August 27, 2021

Re: **Sunoco Pipeline LP – Pennsylvania Pipeline Project (Mariner East II)**  
**Chapter 105 Permit No. E15-862**  
**Major Amendment – HDD S3-0290**  
**Response to Technical Deficiency Comments**  
**Upper Uwchlan Township, Chester County, PA**

In an August 6, 2021 letter from the Department, Sunoco Pipeline, LP (“SPLP”) received technical deficiency comments regarding review of Chapter 105 Major Amendment Request which was submitted to the Department on April 7, 2021 and determined to be complete by the Department on April 16<sup>th</sup> for the 290 HDD location in Upper Uwchlan Township, Chester County (the “290 HDD”). That request of the Department was for a change in the crossing method at Wetland H17 and its associated tributaries from an HDD to an open trench.

**Figure 1.**  
**Option 5a -**  
**Turnpike Reroute**  
**Sheet 1 of 2**

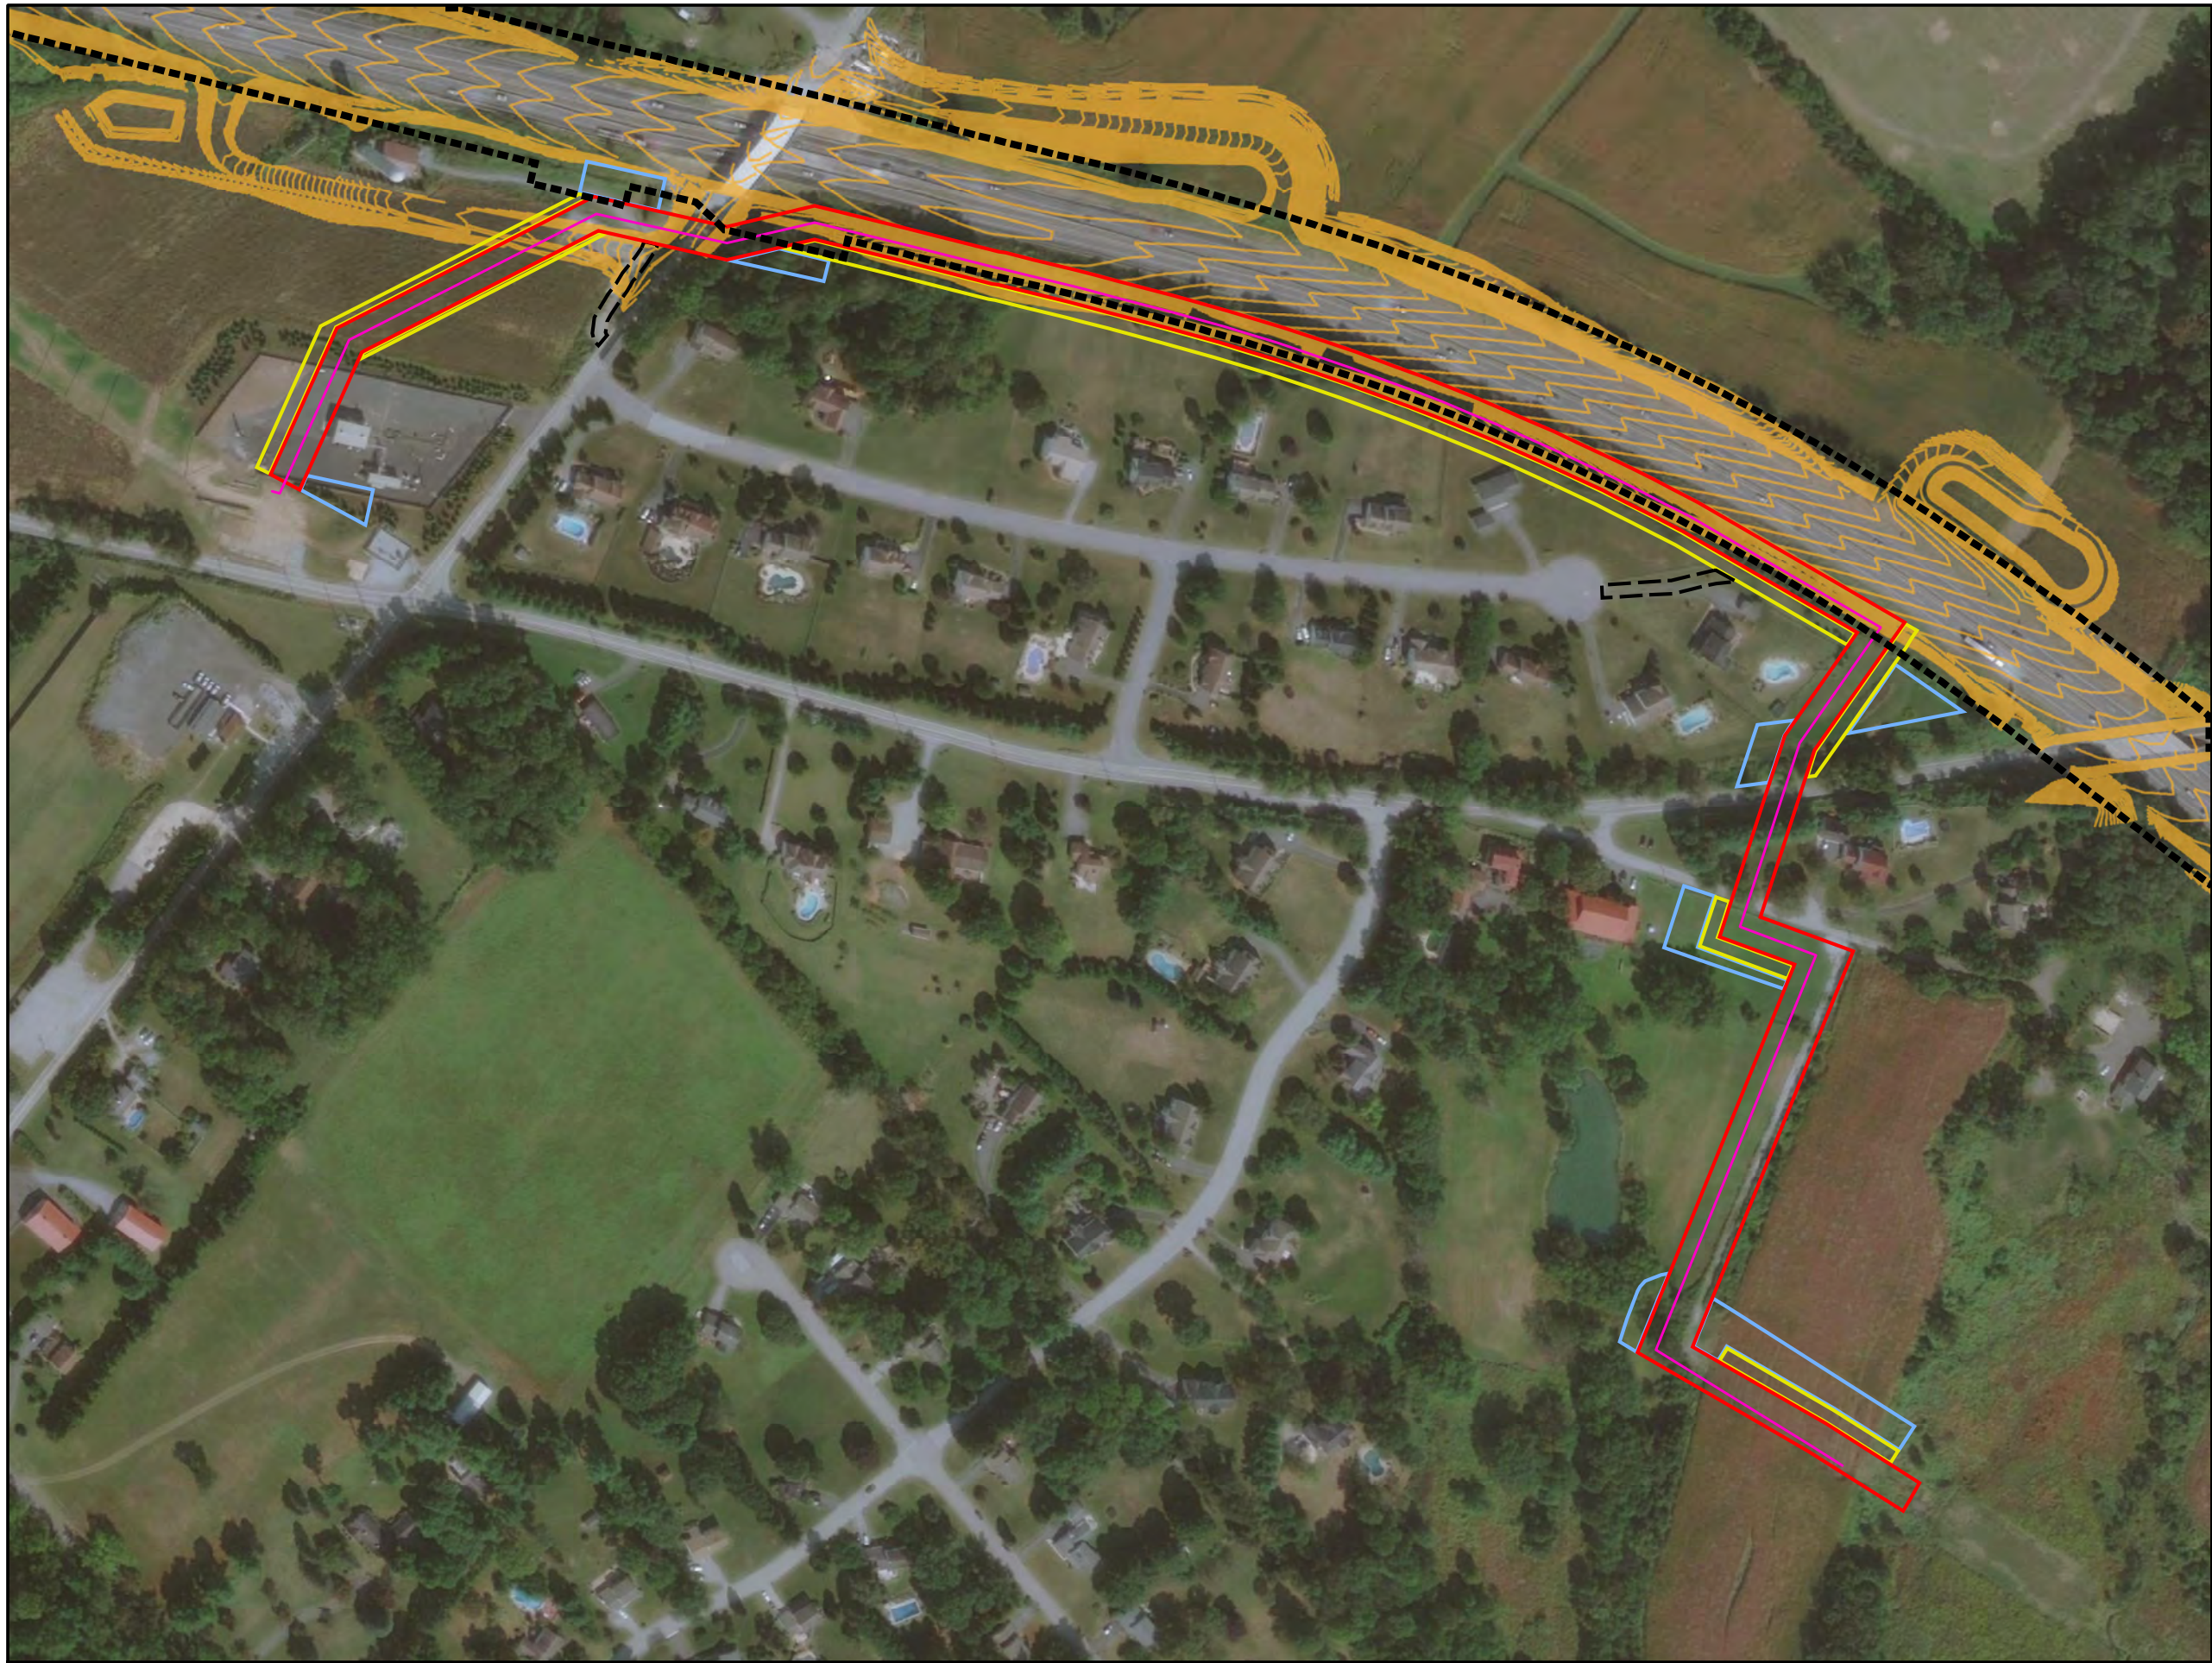
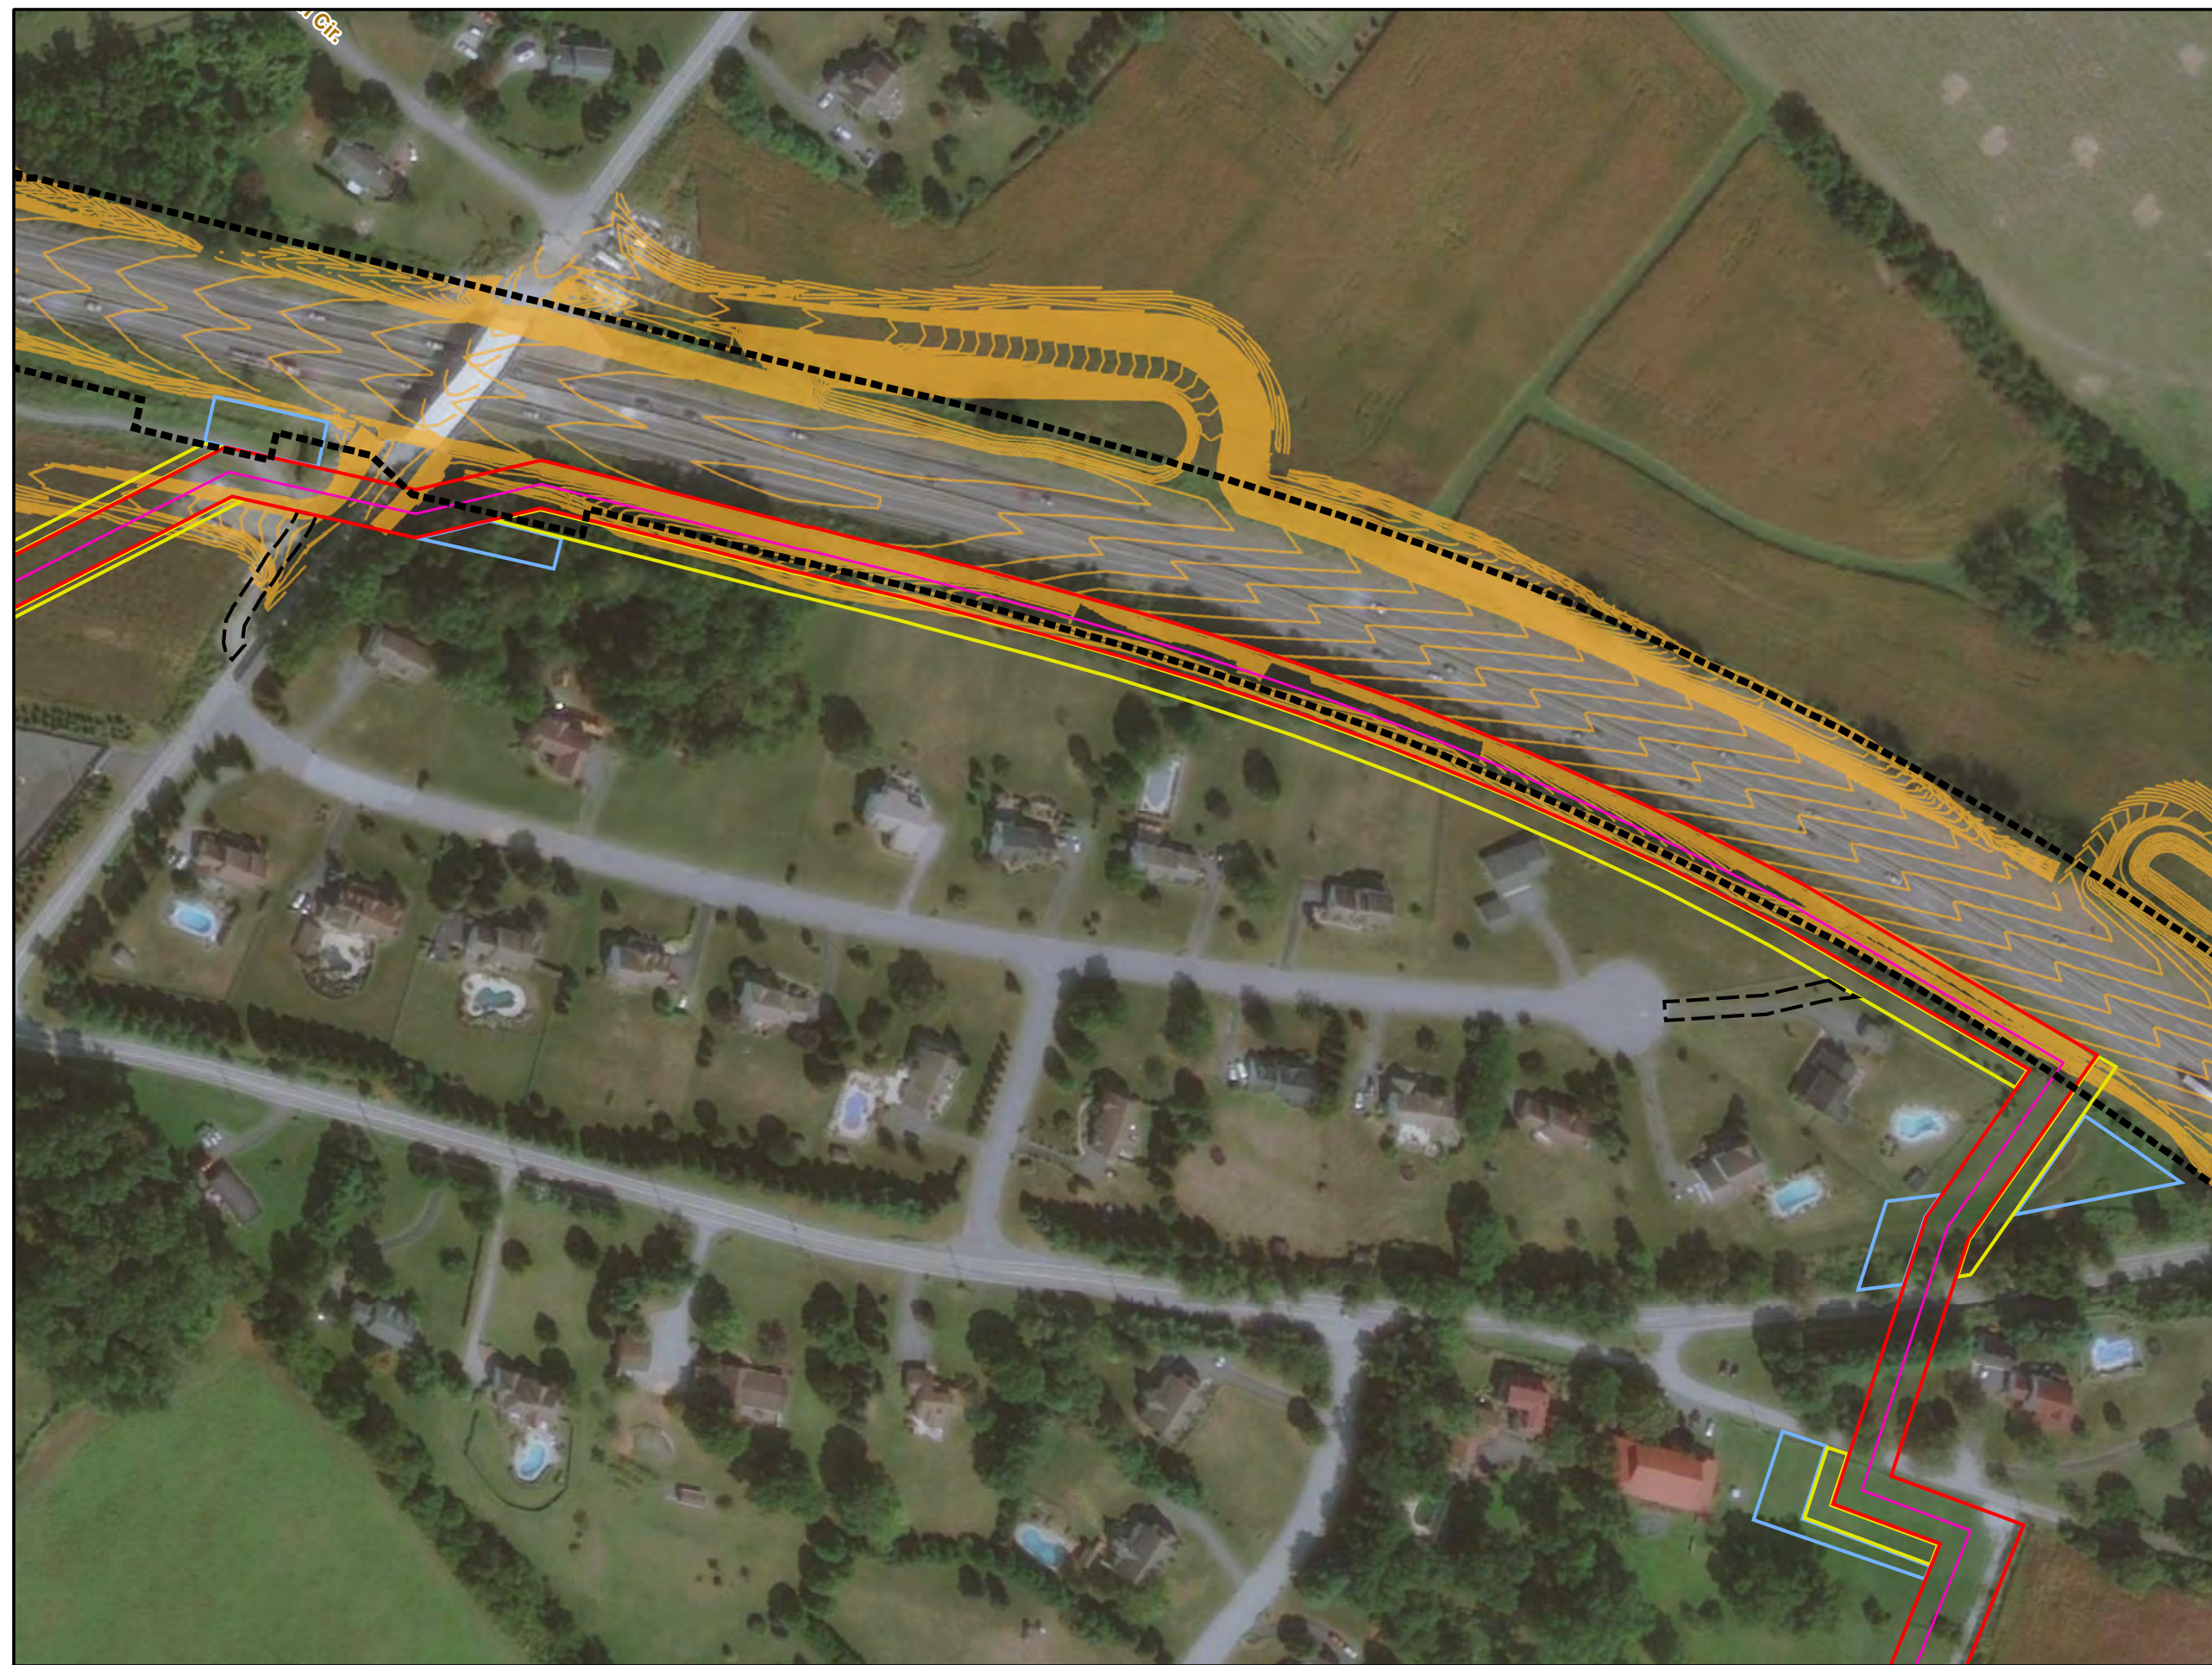
Per TD comment 2, the Department requested that SPLP assess the feasibility of using Option 5a (as termed by the Department), presumed (by the Department) to avoid impacts to wetlands and streams, that would follow the general path of Option 5 but reroute the 20-inch-diameter pipeline to the north of (instead of within) Little Conestoga Road adjacent and parallel to the south side of the Pennsylvania Turnpike. Specifically, Option 5a is concomitant with the open cut construction method routing of Option 5 for approximately 1,138 feet from the eastern start point northward to its intersection with Green Valley Road, then (instead of being routed within Green Valley Road and Little Conestoga Road) continues northward for approximately 464 feet crossing Green Valley Road and Little Conestoga Road to the south side of the Pennsylvania Turnpike, turns westward for approximately 2,755 feet located parallel and as close as possible (given paved road surface and topographic grade) adjacent to the south side of the Pennsylvania Turnpike (overlapping the turnpike right-of-way by approximately 37 feet and northernmost portion of 8 private residential parcels by approximately 13 feet), jogs slightly southwest then west to cross Milford Road, then finally turns southwest and south to interconnect with the SPLP’s Eagle Station. **Figure 1 (Appendix A)** depicts the Option 5a alignment, including the pipeline centerline, 50-foot-wide permanent right-of-way (“ROW”), 25-foot-wide temporary workspace (“TWS”), additional temporary workspace (“ATWS”), and temporary access roads for construction of Option 5a.

The portions of Option 5a located adjacent to the south side of the Pennsylvania Turnpike and in the vicinity of the crossing of Milford Road are located within (the 50-foot-wide permanent ROW almost entirely overlaps) the turnpike’s right-of-way and, moreover, the Pennsylvania Turnpike Commission’s (“Commission’s”) proposed turnpike expansion area, depicted on **Figure 1 (Appendix A)** as “Proposed Turnpike Expansion Grading Contours.” Based on direct consultation with, and letter correspondence (provided in **Appendix B**) from, the Commission, the turnpike “total reconstruction and widening project between Mileposts 308 and 312 will directly impact the pipeline in this location, requiring it to be relocated. Accordingly, the Commission does not support Option 5a.” Therefore, permanent operation of the pipeline within the turnpike expansion area is prohibited by the Commission, and thus the Department-identified Option 5a routing is not available to SPLP and Option 5a is not technically feasible. SPLP has thus eliminated this option from further evaluation.
